## Amesbury Elementary School

# Amesbury School Building Committee December 17, 2020

## Entry Drive Design | Proposed Revision w/ Vehicles

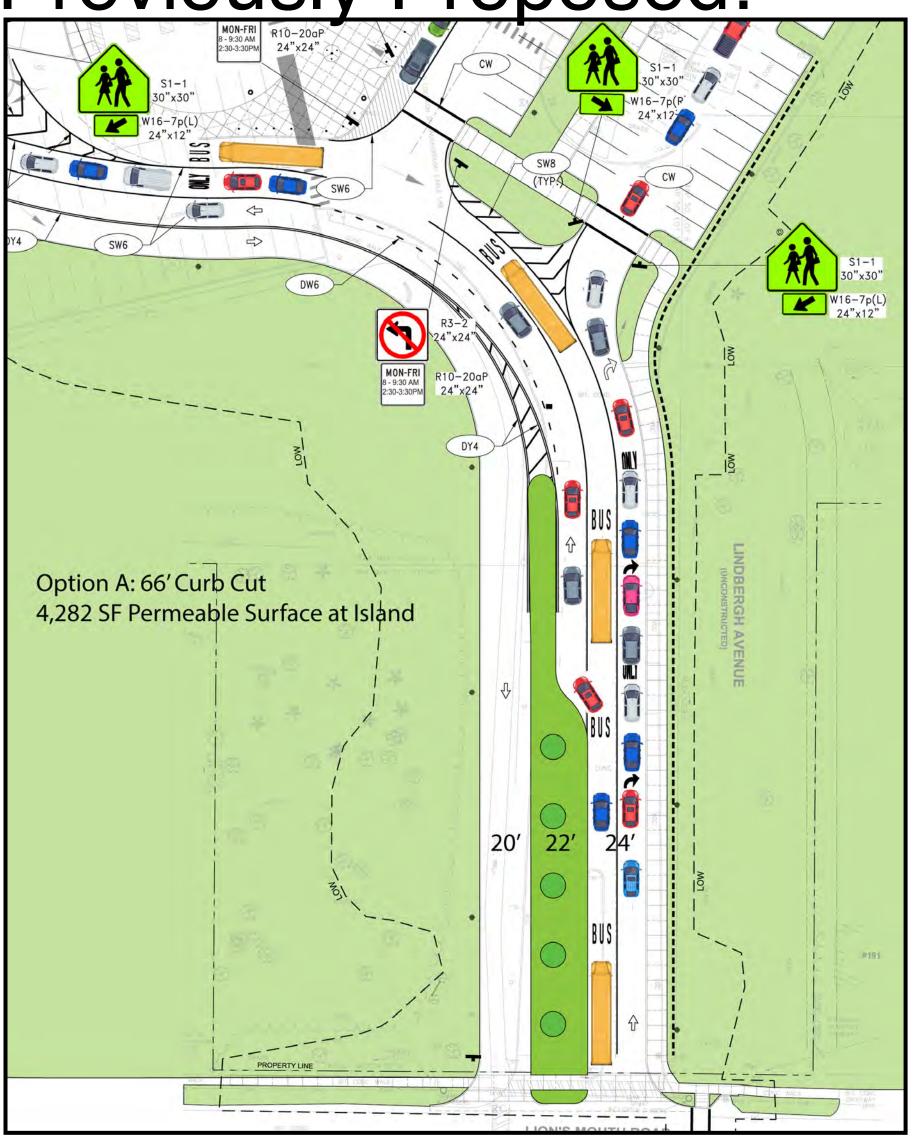
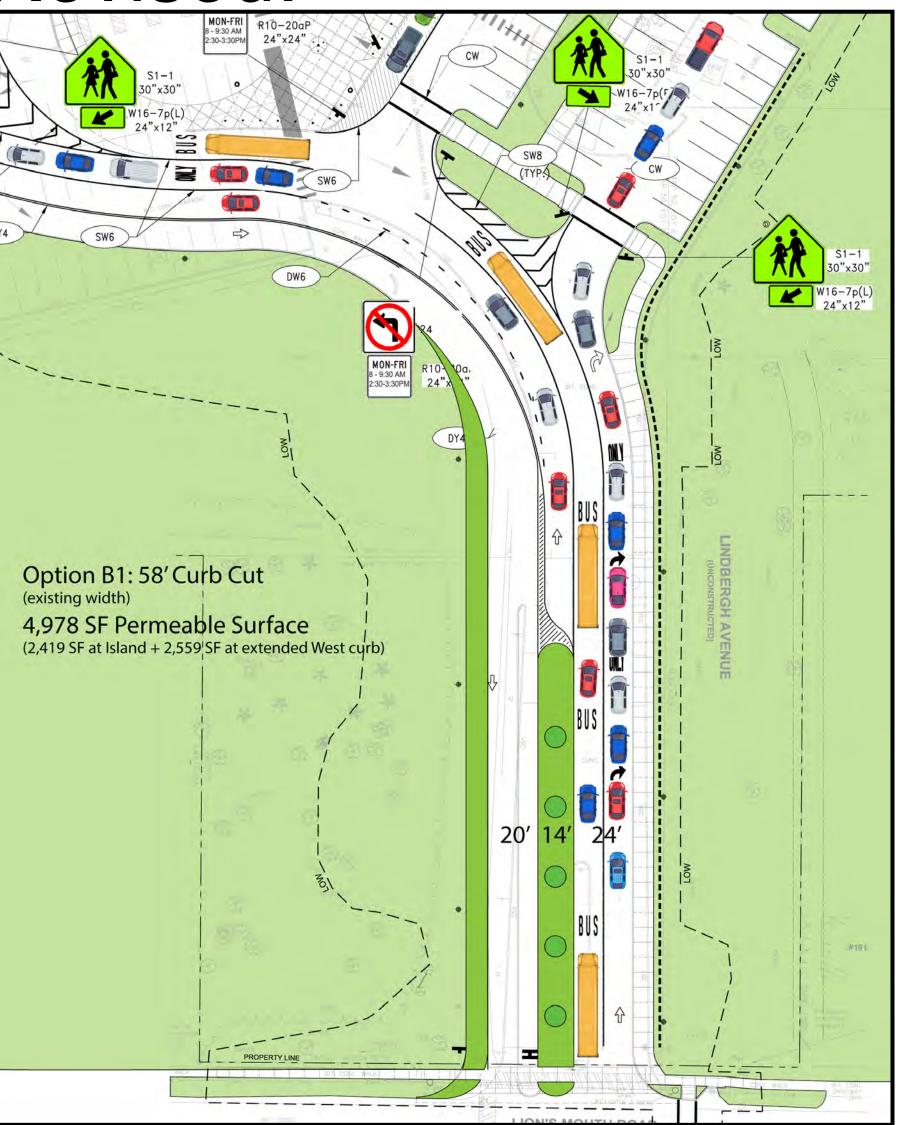
Previously Proposed:

#### Revised:
